July 13, 2022

SLR Project No.: 241.30010.00000

**RE: Drawing Review & Addendum Letter for Environmental Noise
7449 Montrose Road – Niagara Falls**

**Figure 1a: Site Plan of the Proposed development
(Received July 5, 2022)**

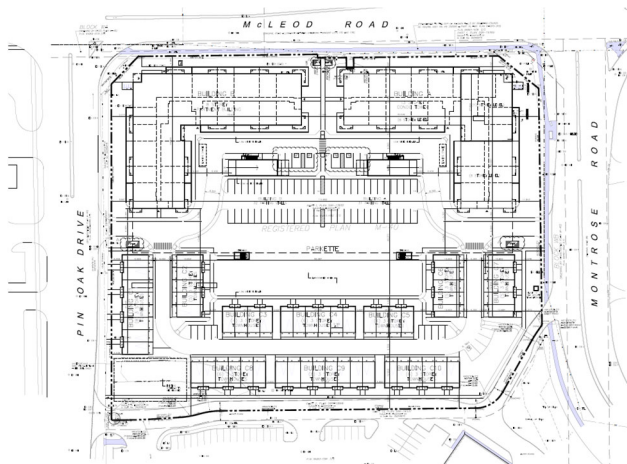
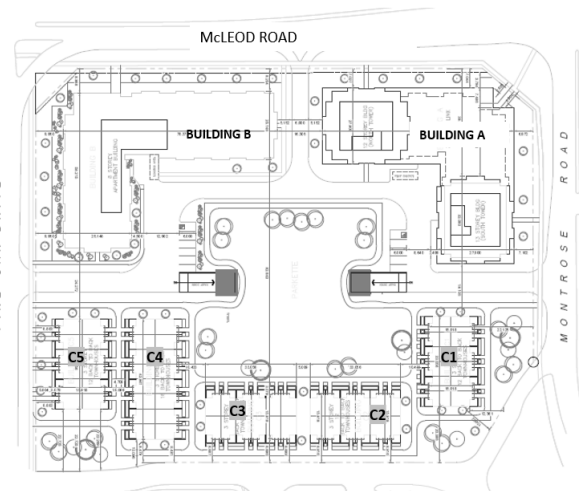
Updated architectural drawings (Image 1a, received July 5, 2022, in support of the OPA/ZBA resubmission) were compared to the original drawings used for the environmental noise predictions (Image 1b, received November 2020). The following relevant differences were noted between the two sets of drawings:

- Previously Building A, in the northeast corner of the site, included a three-storey podium connecting two 13-storey elements. Currently, Building A is 13-storeys in height.
- The location of the numerous townhouse buildings on the south half of the site have been re-arranged. Previously, there were five townhouse buildings (Buildings C1 through C5). Now there are ten townhouse buildings (Buildings C1 through C10). They have remained three-storeys in height.

The major parameters that influence environmental noise results are a change in traffic volumes or setback distances between the roadway traffic or stationary noise sources and the building facades. Changes in building heights should not affect the results. The proposed July 2022 design changes do not shift any of the buildings substantially closer to the transportation or surrounding stationary noise sources. Therefore, we do not anticipate the predicted sound levels or conclusions of the February 2021 report to change.
